NOTICE OF MEETING
PLANNING AND ZONING COMMISSION
6:30 P.M. – January 16, 2020

PLANNING AND ZONING COMMISSION ITEM:
PC-19-20
PRELIMINARY PLAT
CIBOLO CLIFF RANCHES

SUBJECT: Cibolo Cliff Ranches Subdivision
Preliminary Plat Review No.3

This letter is in response to the letter received from Half Associates, Inc, as it pertains to the Cibolo Cliff Ranches Subdivision Preliminary Plat Review. The comments received are in italics and our responses are in bold.

TYPICAL SETBACK ON INTERIOR PROPERTY LINE

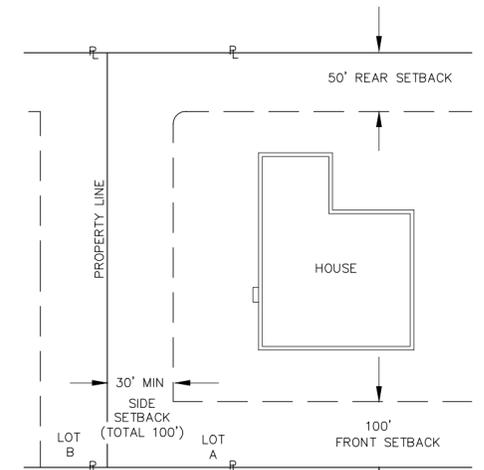
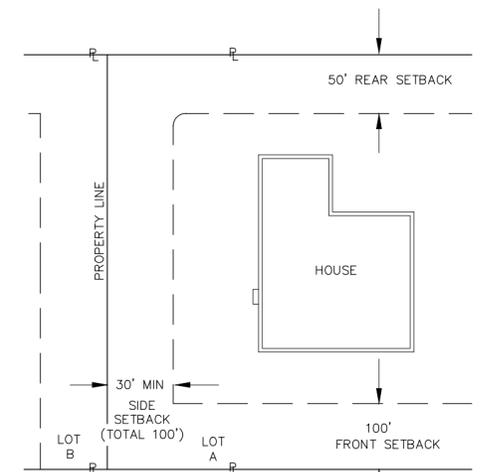
17. Missing setback lines, legend, abbreviations and street ROW lines. – Setback lines are incorrect for low density lots (Subdivision Code Section 2.03). Front setback = 100', side setback = 40', rear setback = 50'. Show setback lines on plat in addition to typical exhibit. Legend is missing on Sheet 3. Lot 900 shows as a Private ROW Lot as well as Cibolo Cliffs Way ROW. The boundary lines indicate separate lots (Sheets 8 & 10). The Match Line and Boundary Line of the Lots/Cibolo Cliffs Way interfere with one another and are not correctly represented between sheets. – **Typical Setback Exhibit has been revised, however setbacks are not shown on platted lots. Please include setback lines so it is clear to property owners where they can place structures.**

Review 2: – Setback lines are incorrect for low density lots (Subdivision Code Section 2.03). Front setback = 100', side setback = 40', rear setback = 50'. Show setback lines on plat in addition to typical exhibit. Legend is missing on Sheet 3. Lot 900 shows as a Private ROW Lot as well as Cibolo Cliffs Way ROW. The boundary lines indicate separate lots (Sheets 8 & 10). The Match Line and Boundary Line of the Lots/Cibolo Cliffs Way interfere with one another and are not correctly represented between sheets.

The detail for the setbacks has been updated on Sheet 1 to match the Subdivision Code. Legends have been added to every page. The match lines and boundary lines have been updated to different line types. Match lines and viewports have been adjusted for more clarity.

INDEX MAP DETAIL

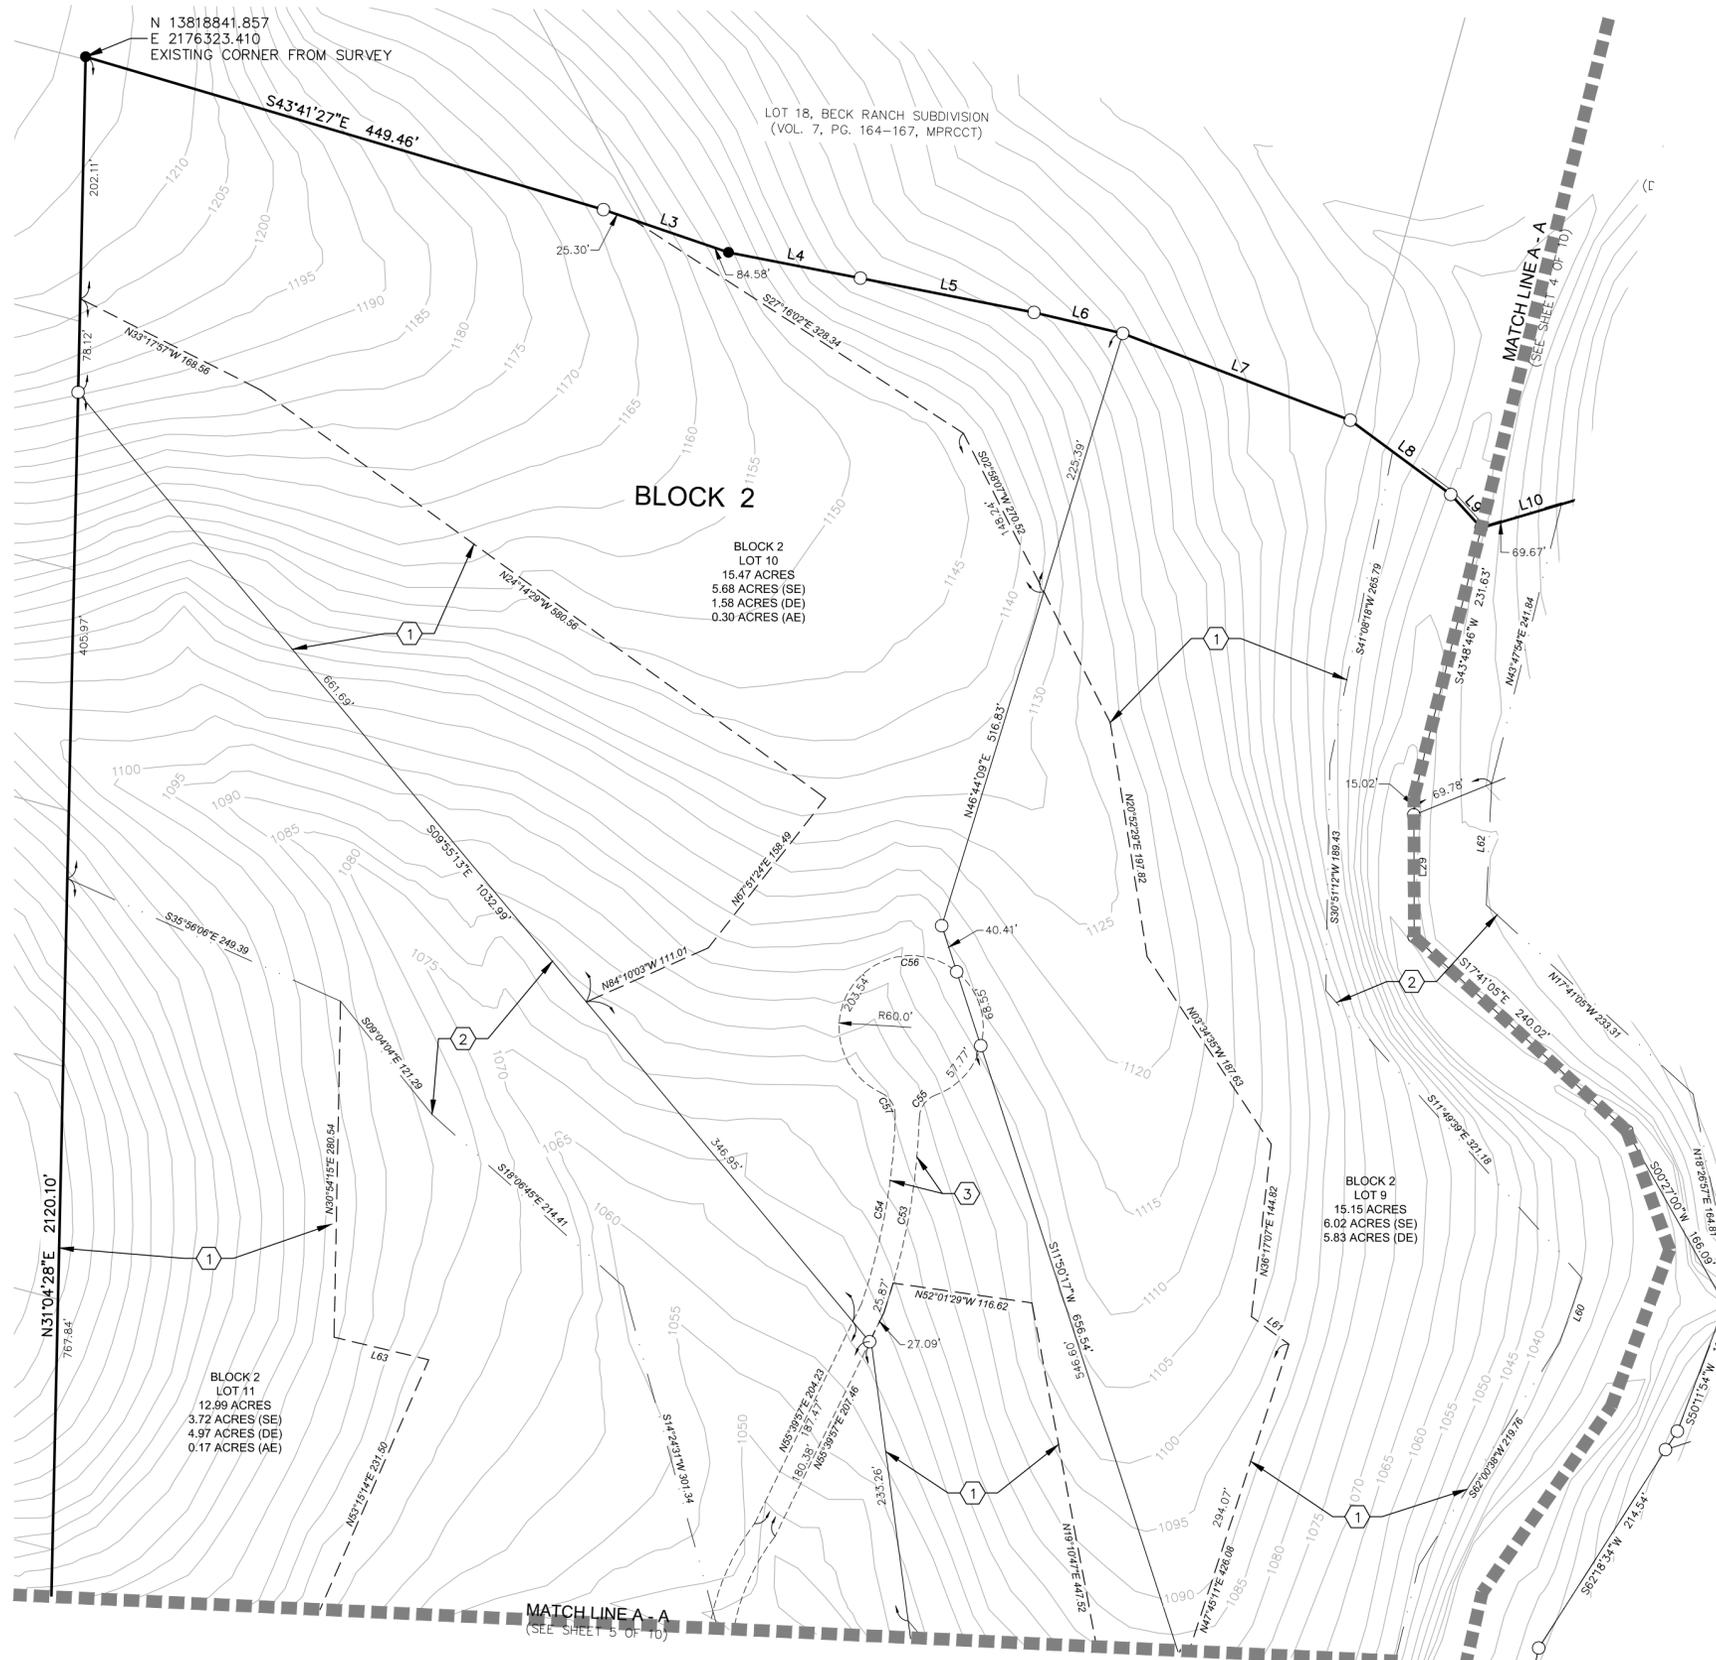
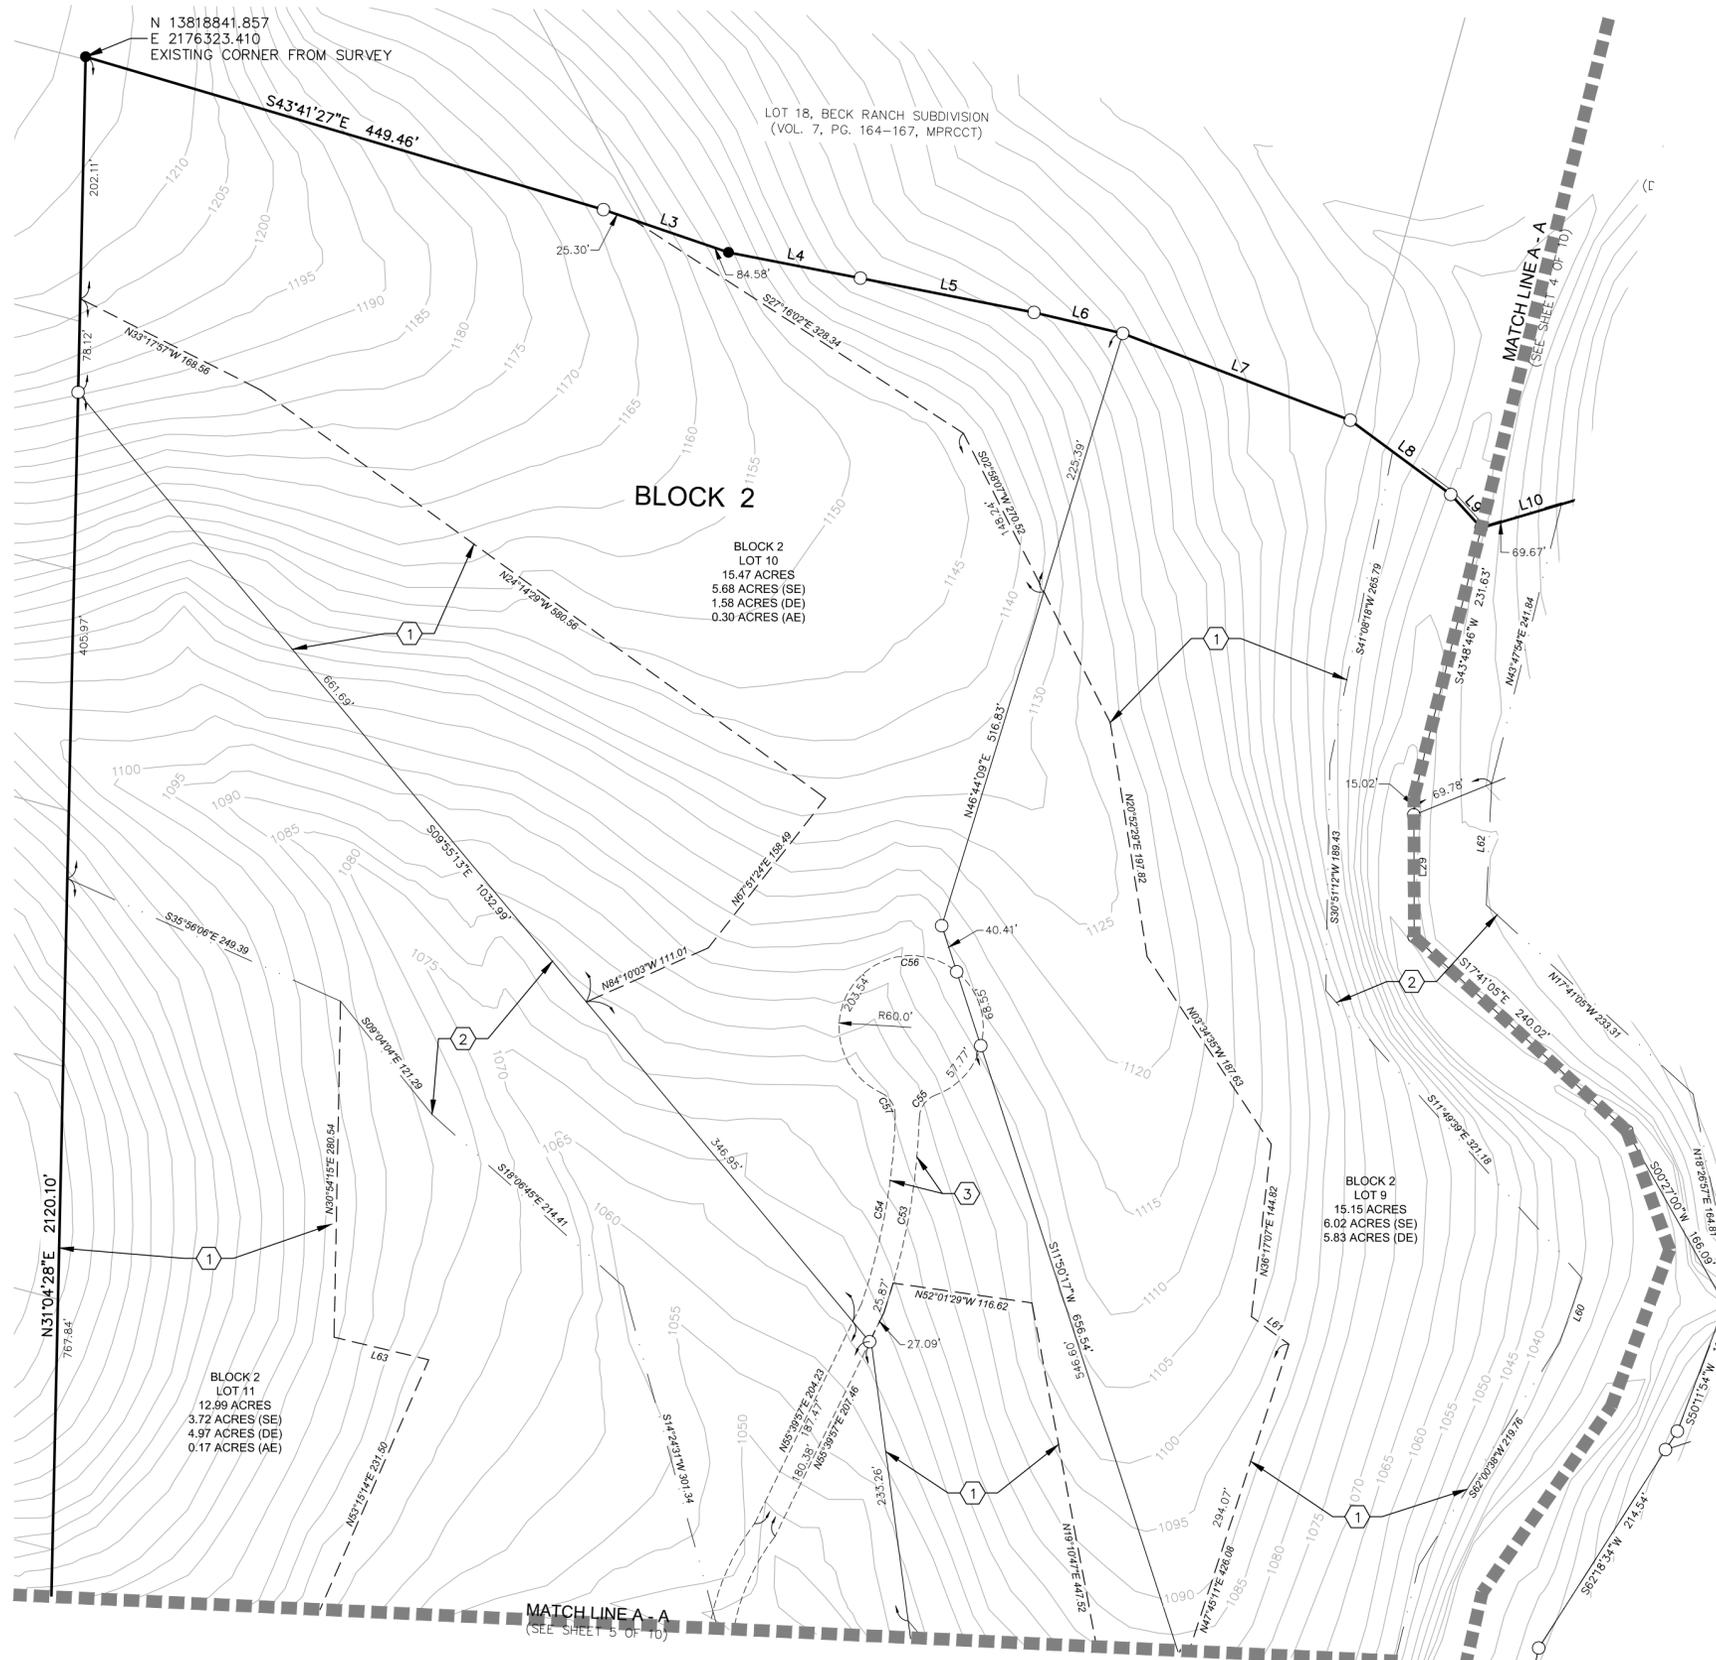
8. A minimum of two corners of the subdivision referenced to State Plane Grid Coordinates. – [comment resolved](#)
9. Show city limits and limits of the City's ETJ on location map and plat (i.e. FM 1863) – Plat shows and labels City Limits on Sheets 9 & 10, shows City Limits on Sheet 7 but not labeled. Not shown on Location Map (Sheet 1), Shown but not labeled on Index Map (Sheet 2) – [comment resolved](#)
